# St. Lucie Unit 2

## NRC Update SL2-13 November 2001 Steam Generator Inspection Plans

STEAM GENERATOR TUBE INSPECTION DISCUSSION POINTS  
 PREPARED BY THE OFFICE OF NUCLEAR REACTOR REGULATION  
 FLORIDA POWER AND LIGHT COMPANY  
 ST. LUCIE PLANT, UNIT 2  
 DOCKET NO. 50-389

STEAM GENERATOR TUBE INSPECTION DISCUSSION POINTS  
PREPARED BY THE OFFICE OF NUCLEAR REACTOR REGULATION  
FLORIDA POWER AND LIGHT COMPANY  
ST. LUCIE PLANT, UNIT 2  
DOCKET NO. 50-389

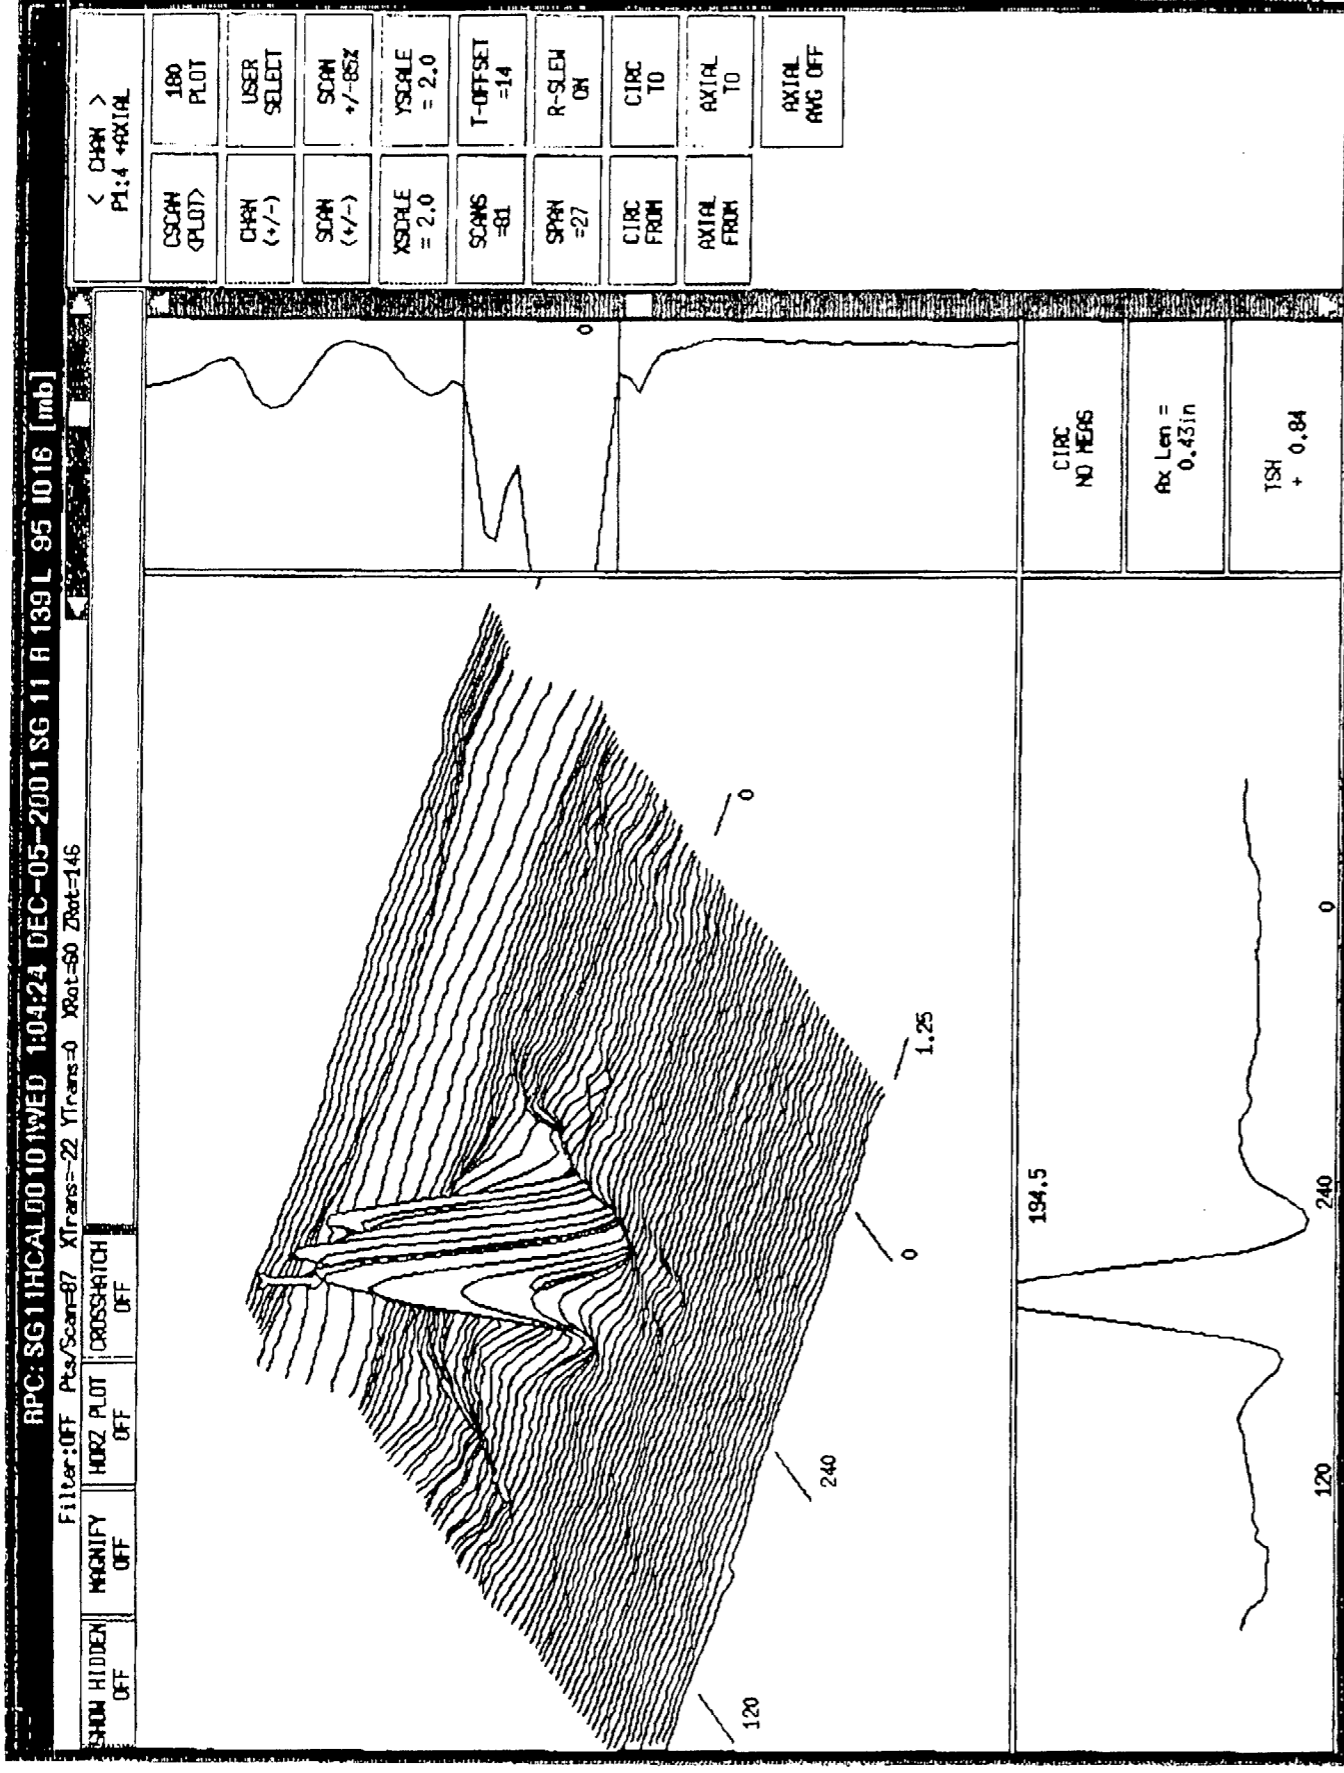
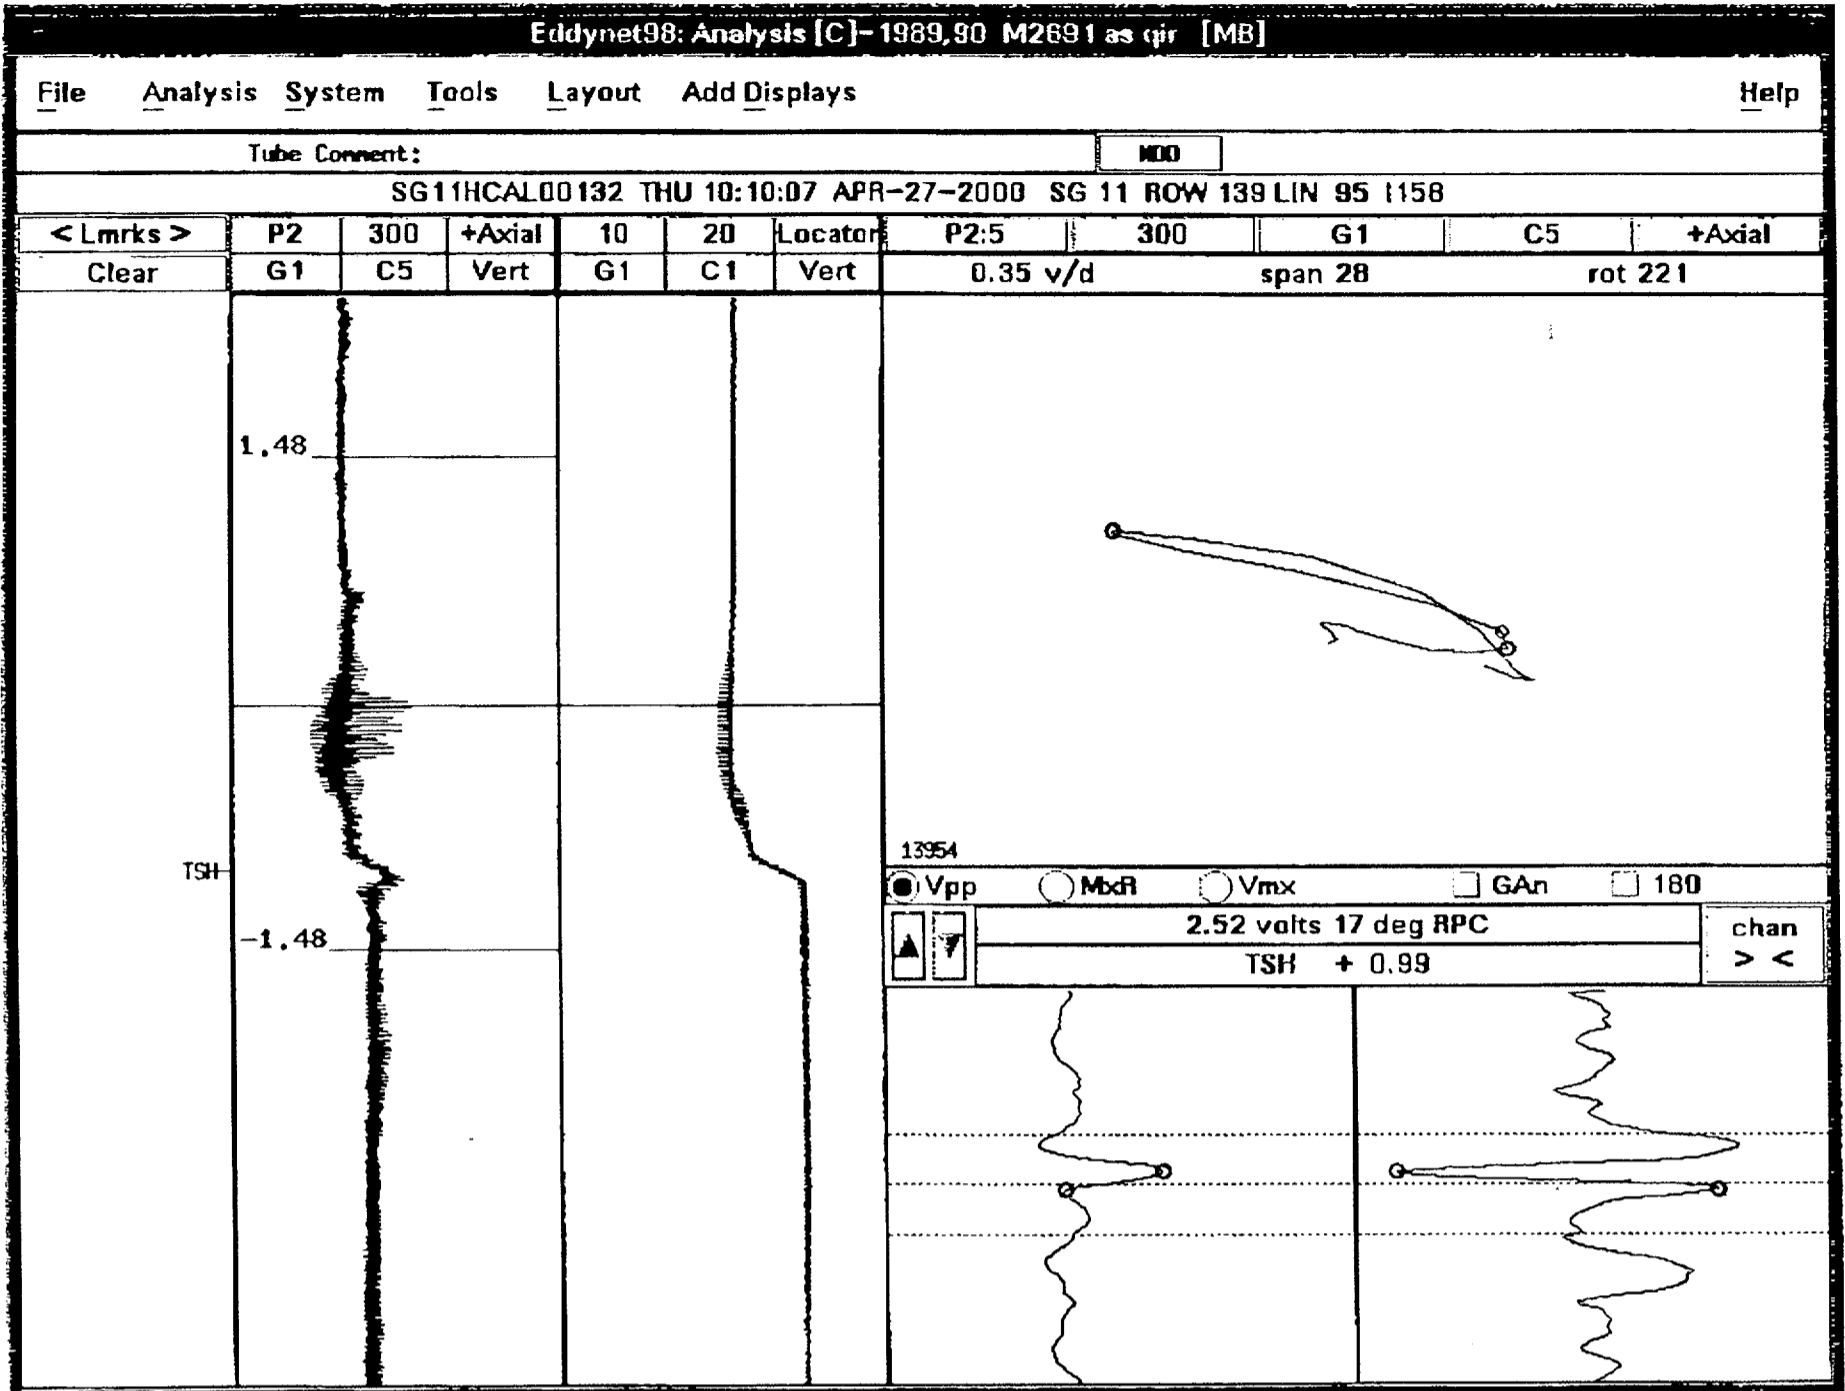
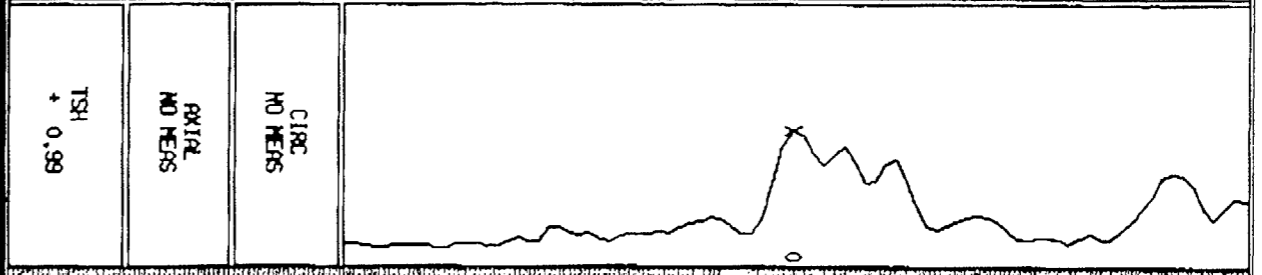
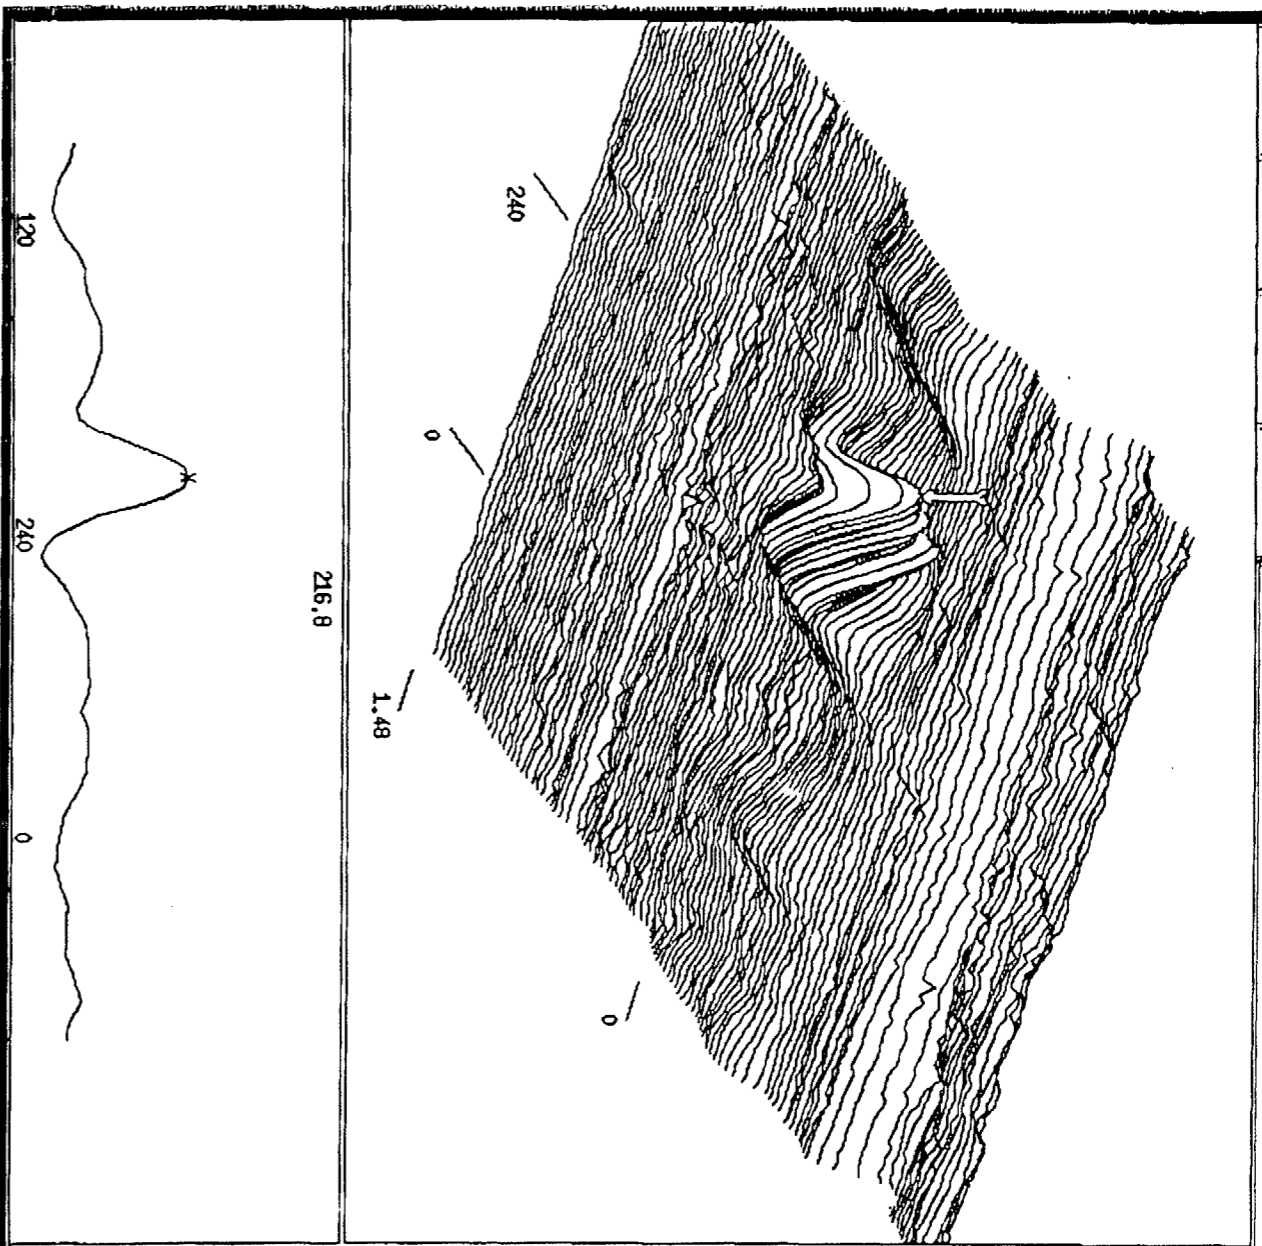
**Issue 1:** Provide eddy current graphics and discuss the evolution of the worst indications detected in dents (See Attachment 1 – 13 Pages).
